UNITED STATES PATENT AND TRADEMARK OFFICE

APPLICATION NO.	FILING DATE	FIRST NAMED INVENTOR	ATTORNEY DOCKET NO.	CONFIRMATION NO.
10/814,204	03/31/2004	Shouchun Xie	KANGX4.001AUS	6008
20995	7590	08/22/2006	EXAMINER	
KNOBBE MARTENS OLSON & BEAR LLP 2040 MAIN STREET FOURTEENTH FLOOR IRVINE, CA 92614				BROWN, DREW J
		ART UNIT		PAPER NUMBER
		3616

DETAILED ACTION

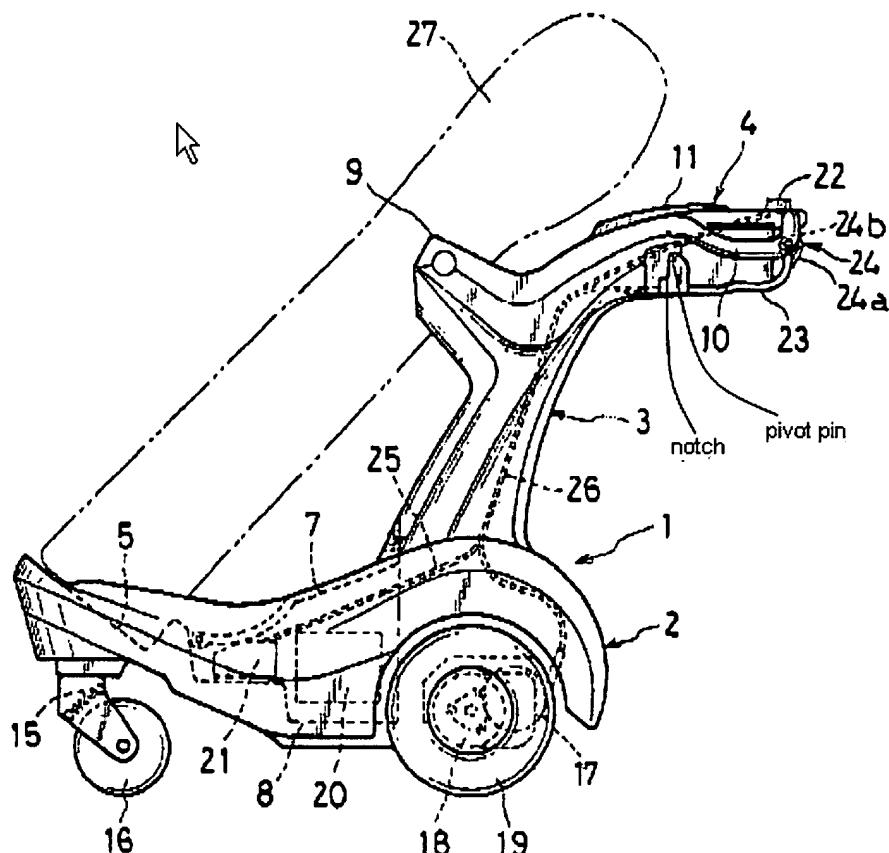
Furuta does disclose that the controller (21) is provided under the supporting platform (Figure 1), and that regenerated braking of the electrical hub is performed by an electrical control system (column 6, lines 52-63). Furuta also discloses a braking grip (23) that is provided on the handle frame and electrically connected with the left controller and the right controller. The braking grip has a first end thereof pivotally connected with a fixing seat formed on one end of the handle frame via a pivot pin, and has a notch defined therein proximal to the first end thereof (as shown in the Figure below).

Therefore, it would have been obvious to one having ordinary skill in the art at the time the invention was made to modify the invention of Wang in view of the teachings of Furuta to provide the controller under the supporting platform in order to create more space above the platform for the occupant to stand, and also to protect it from being damaged due to inclement weather. It also would have been obvious to use an electrical control system for braking of the electric hub so additional braking elements are not needed, which would reduce the cost of manufacturing and also reduce the weight of the vehicle.
